Torque Converter Flex Lock-up Shudder

Service Category Drivetrain

Section Automatic Transmission/Transaxle

Market Mexico

Figure 1. Magnet Installation Locations

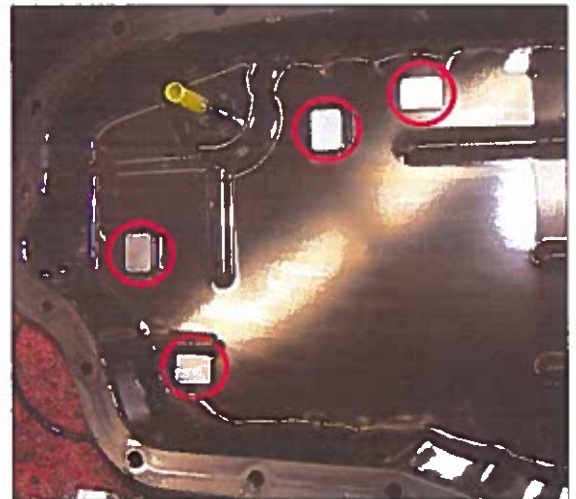
6. Install 4 NEW magnets in the locations shown in Figure 1.

Figure 2. Location of Authorized Modifications Label on 2012 – 2014 Camry

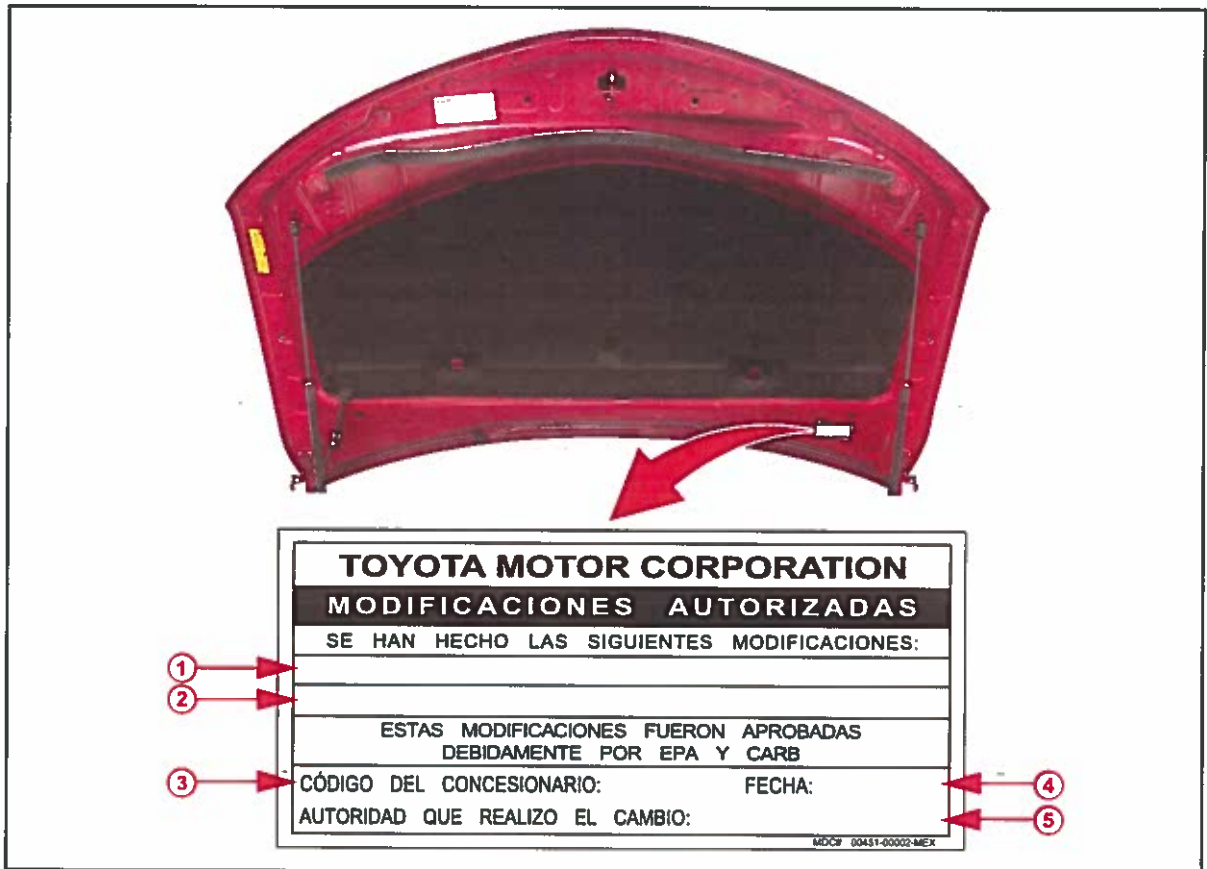
- 2012 / 2013 / 2014 Camry:
Drivetrain – Automatic Transmission/Transaxle – “U760E Automatic Transmission/Transaxle: Automatic Transaxle Fluid: Replacement”
- Check for the Authorized Modifications Label affixed to the vehicle in the location shown in Figure 2 below. Confirm if the ECM (PCM) calibration has been updated. If the calibration ID listed is NOT the latest ECM (PCM) calibration — go to step 10. If the calibration ID is the latest, go to step 12.
